Addendum No. 1

Subject: LOUIS H. FARRELL ELEMENTARY SCHOOL
CLASSROOM MODERNIZATION
SDP CONTRACT NOS. B-029 C, B- 031 CC

Location: LOUIS H. FARRELL ELEMENTARY SCHOOL
8300 Castor Avenue
Philadelphia, PA 19152

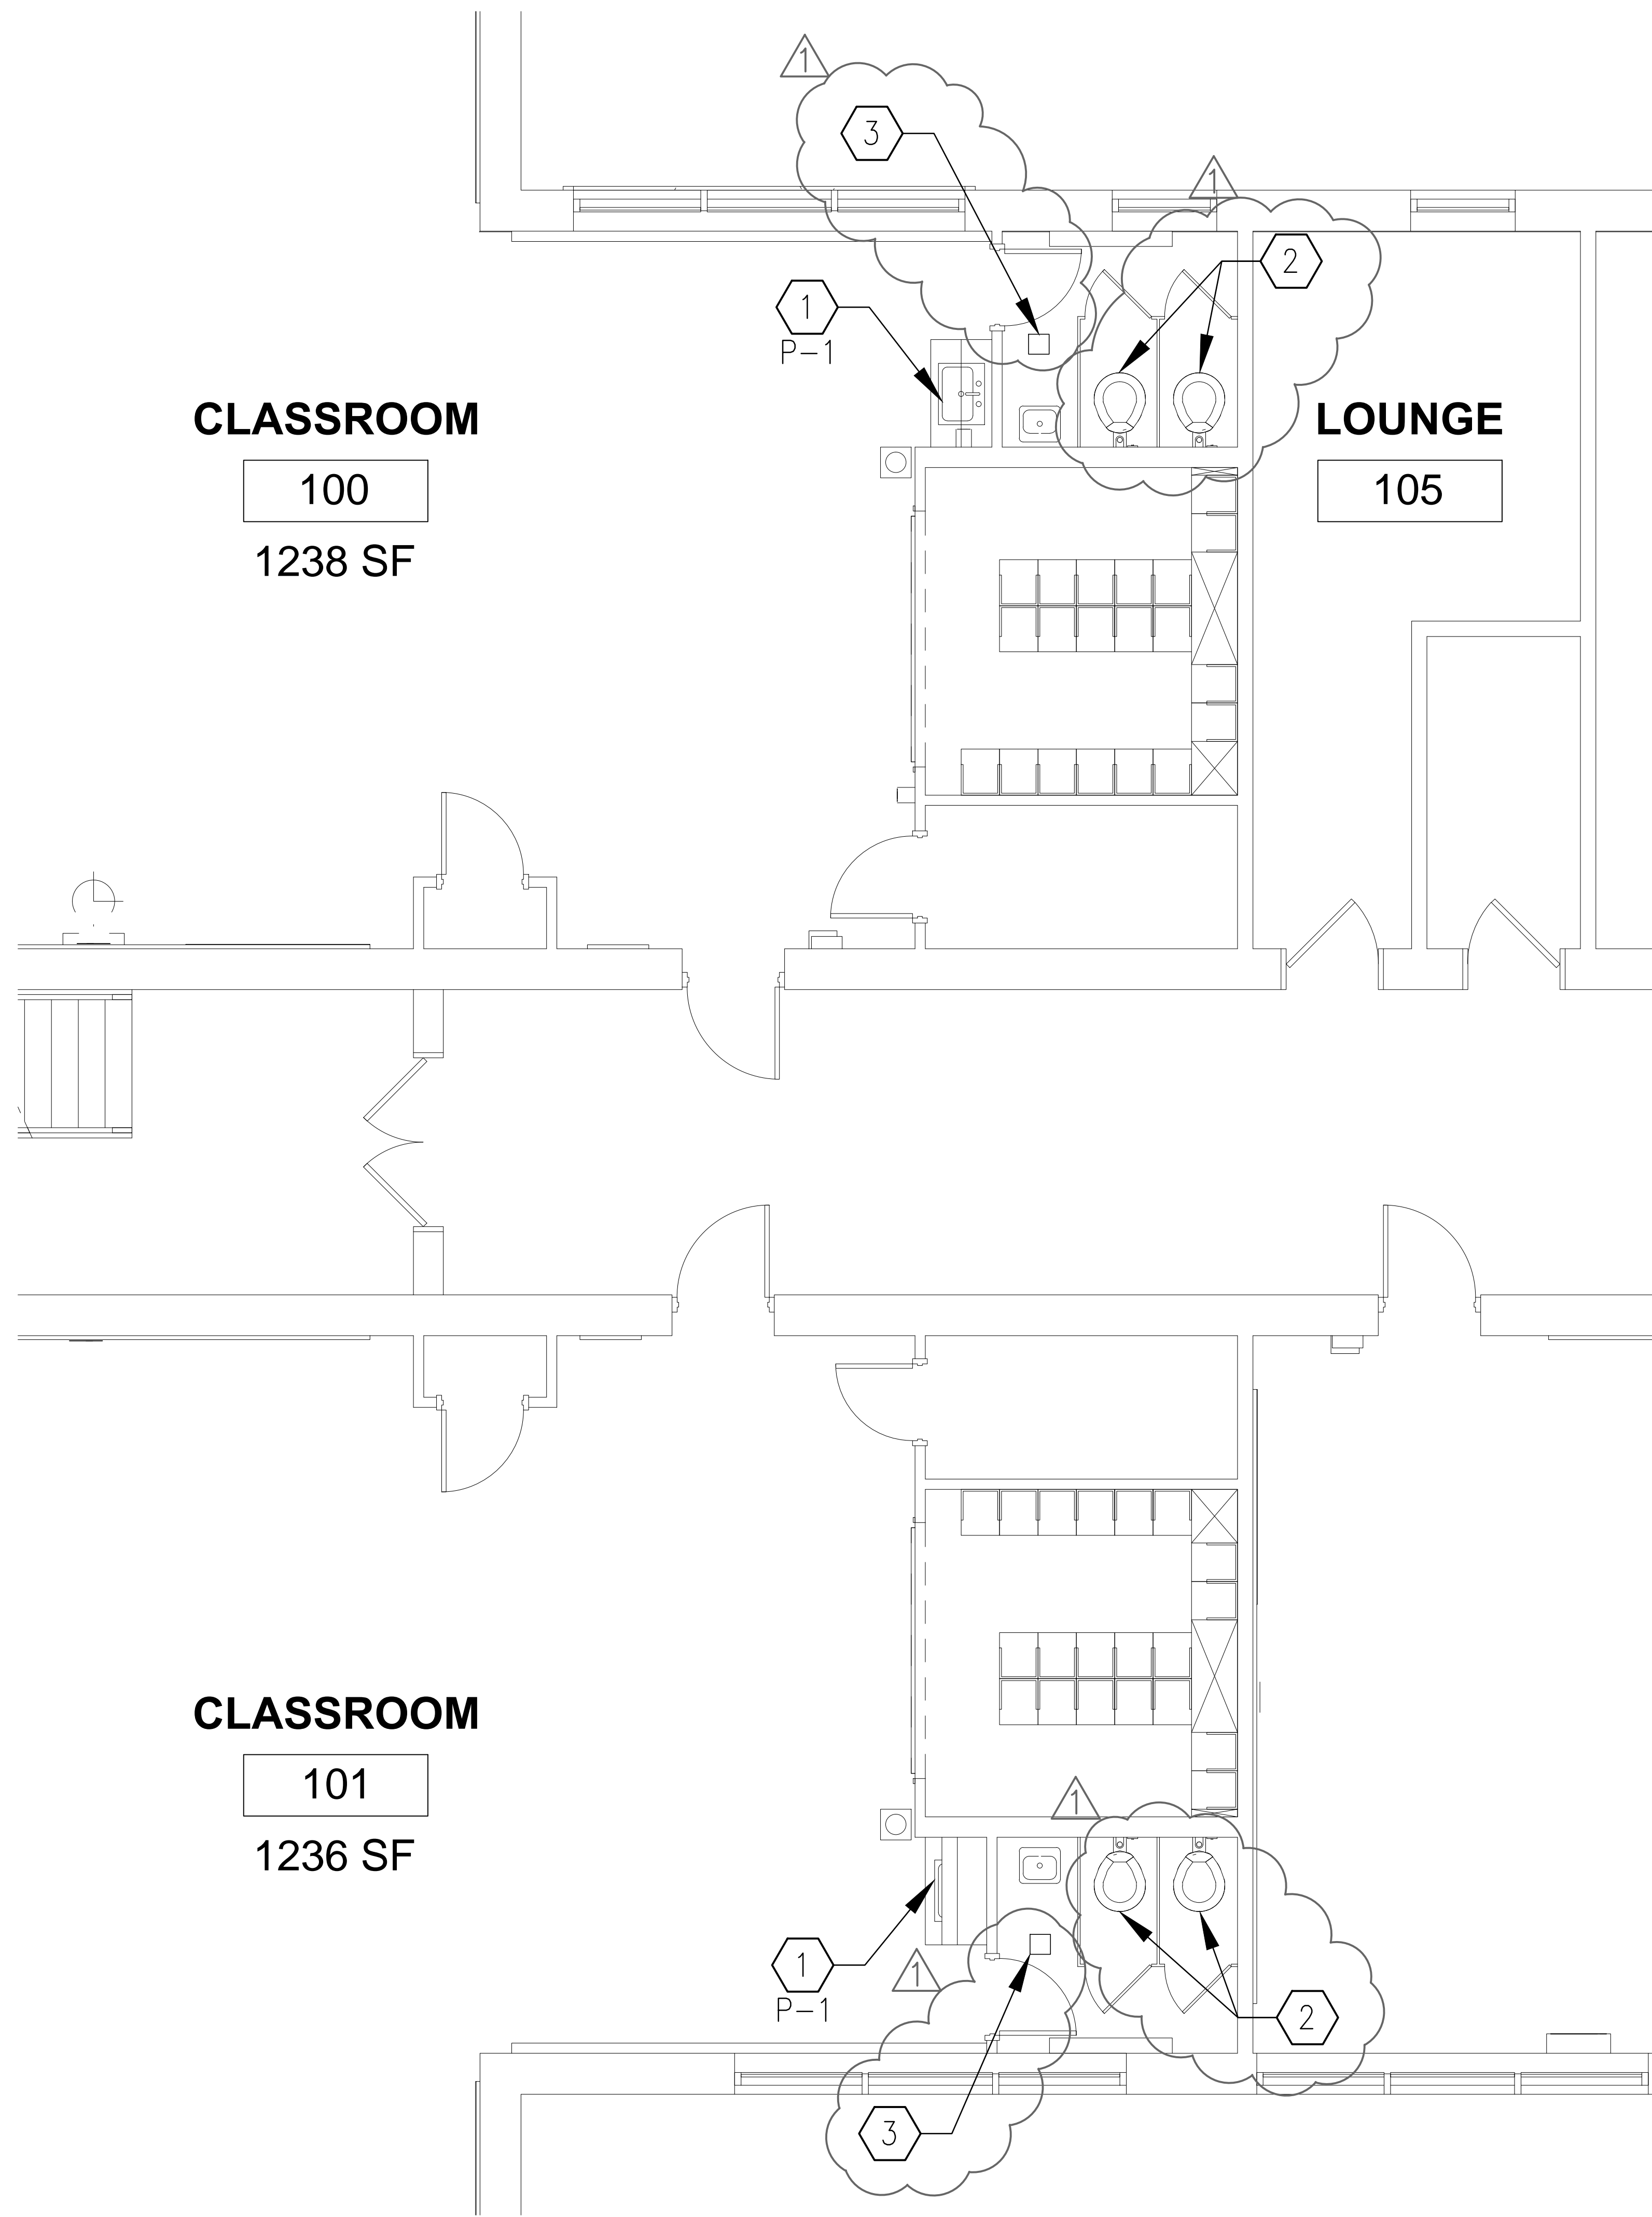
.7 **Clarification:** DWG. E501 DATA RISER DIAGRAM: The contractor is responsible from classroom termination to patch panel termination. Contractor is also responsible for testing each new cable for proper connectivity and LABELING each and every new cable with classroom number and closet number. SDP is responsible for all network switching equipment within the closets and patching in that equipment to the new panels.

ELECTRICAL PANEL SHROUD DETAIL

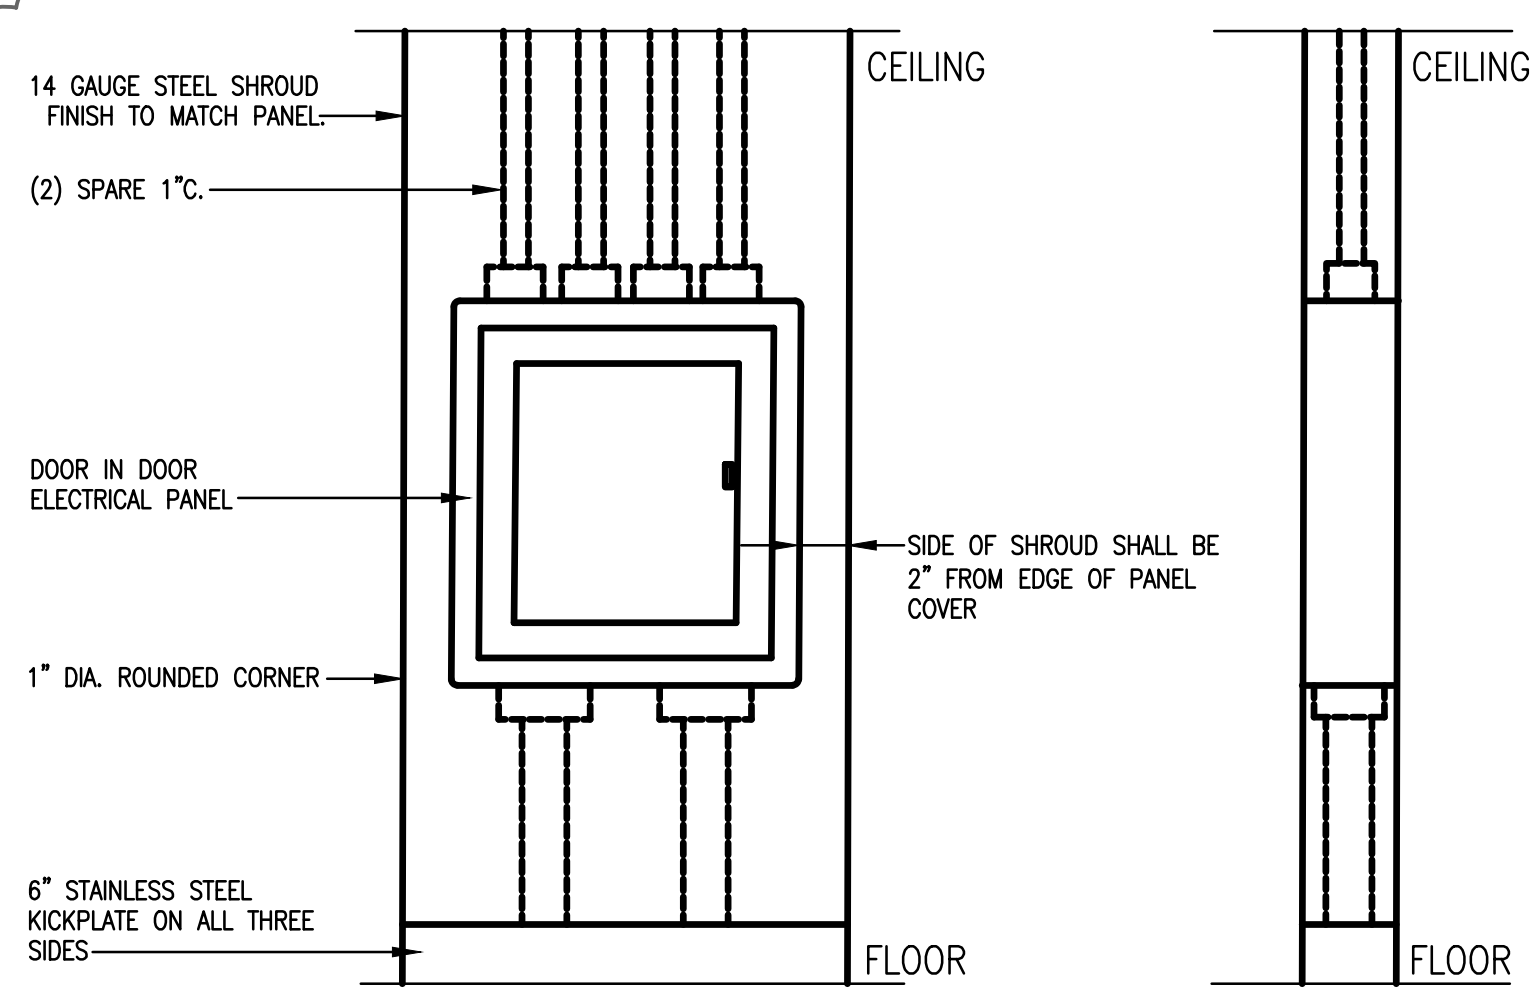
14 GAUGE STEEL SHROUD
FINISH TO MATCH PANEL

6" STAINLESS STEEL
KICKPLATE ON ALL THREE
SIDES

SIDE OF SHROUD SHALL BE
2" FROM EDGE OF PANEL
COVER

STEEL SHROUD SHALL BE SCREWED TO
ANGLE WITH TAMPER PROOF STAINLESS
STEEL FASTENERS. (TYP.)

2"X2" AND 1/2" THICK STEEL
ANGLE & BOLTED TO WALL
WITH STAINLESS STEEL
FASTENERS. (TYP.)

Metal Box Speakers

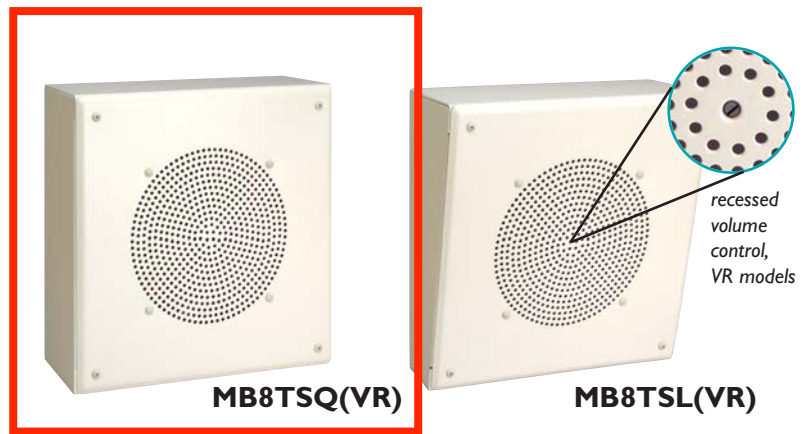
.10 **Clarification:** Where EC is to replace non-functioning speakers and wall telephones the EC shall provide the speakers (see attached cut sheet). SDP will furnish new telephone handsets for installation by EC.
